UNITED STATES PATENT AND TRADEMARK OFFICE

APPLICATION NO.	FILING DATE	FIRST NAMED INVENTOR	ATTORNEY DOCKET NO.	CONFIRMATION NO.
10/567,960	09/11/2006	Peter Bauer	2003P01107W0US	3690
46726 7590 03/24/2009 BSH HOME APPLIANCES CORPORATION INTELLECTUAL PROPERTY DEPARTMENT 100 BOSCH BOULEVARD NEW BERN, NC 28562				
EXAMINER ROGERS, LAKIYA G				
ART UNIT		PAPER NUMBER		
3744				
MAIL DATE		DELIVERY MODE		
03/24/2009		PAPER

Office Action Summary

DETAILED ACTION

Fig. 1

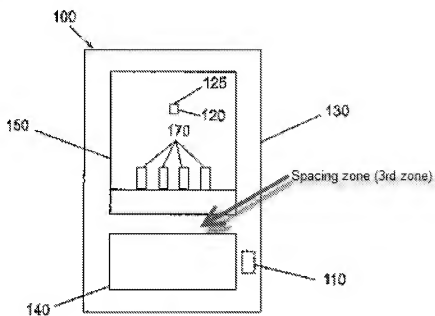
Regarding claim 12, Simmons teaches a refrigerating appliance (100) comprising a heat-insulating housing (130; Page 6, lines 14-16) and a cooling circuit including an evaporator (590), a compressor (560) and a condenser (570), a first assembly (150) including at least the housing and the evaporator; a second assembly (140) mounted remotely from the first assembly and separated therefrom by a spacing zone (see annotated figure below), said second assembly including at least the

Regarding claim 12, as currently presented does not recite the limitation of the refrigerating appliance being housed within kitchen furniture. Simmons teaches in Fig. 1 that the second assembly is mounted remotely from the first assembly and a coupling assembly extending across the spacing zone between the first and second assembly as recited and shown above in annotated Fig. 1. For the purpose of this examination, examiner presumes the word remotely to mean *situated at some distance away*.

Simmons ('350) teaches in Fig. 1 the technique of separating the first and second zone by a third zone with the third zone being devoid of the of the first and second assemblies as recited and illustrated above in annotated Fig. 1.

Fig. 2

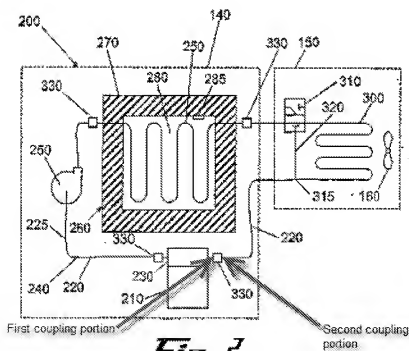
Regarding claim 13, Simmons teaches the invention as recited above and further teaches in Fig. 2 including a coupling (330) disposed in a coolant pipe (220) connecting the first assembly and the second assembly (Page 8, lines 9-10 and lines 33-34).

Regarding claim 14, Simmons teaches the invention as recited above and further teaches in Fig. 2 (see annotated Figure 2 below) the refrigerating appliance wherein the coupling (330) including a first coupling portion capable of being attached to the first assembly (150) and a second coupling portion attached to the second assembly (140), the two coupling portions are self-closing in the uncoupled state allowing the first assembly and the second assembly to be detachably separable from one another (Page 8, line 33-Page 9, line 5) for remote mounting of said first assembly and said second assembly separated by said spacing zone.

Regarding claim 16, Simmons teaches the invention as recited above and further teaches in Fig. 2 the refrigerating appliance including the condenser (570

Regarding claim 20, Simmons teaches in Figs. 1 and 2 an assembly for a refrigerating appliance, comprising: a heat-insulating housing (130; Page 6, lines 14-16); an evaporator (590); and at least one coupling portion (330) from which at least one of an inlet or drain pipe (220) for a coolant extends to the evaporator (cold producing unit (210); Fig. 2; Page 12, lines 28-29).
